**Interim Recall**

NHTSA #18V-192 (School Buses) #18V-193 (Non-School Buses) Transport Canada #18-142

## Subject: TBB SynTec S3B Seat Frames (Non-Restraint Seats)

Models Affected: Thomas Built Buses Saf-T-Liner C2, EFX, and HDX buses and Minotour buses manufactured August 27, 2014, through February 5, 2018.

Figure 3: Addition of the New Bracket

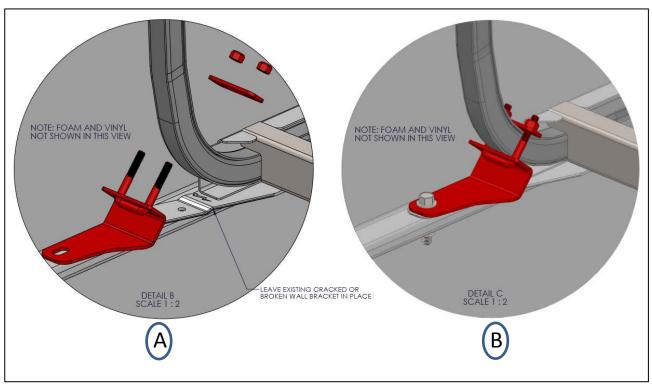
- 5. Place the new bracket over the existing, broken bracket and install the seat rail nut and bolt. (Reposition the broken piece to its original placement.) Do not tighten at this point. See Figure 3, Item A.
- Install the U-bolt, plate, and nuts. Using a 1/2 inch socket, tighten to 5 lbf lbs See Figure 3, Item B.

- 7. Tighten the rear seat rail nut and bolt to 12 lbf lbs.
- Install the seat cushion.
- If more than one bracket is cracked or broken, repeat this procedure for each cracked/broken bracket. (This is expected to be rare.)
- 10. Remove the chocks from the tires.
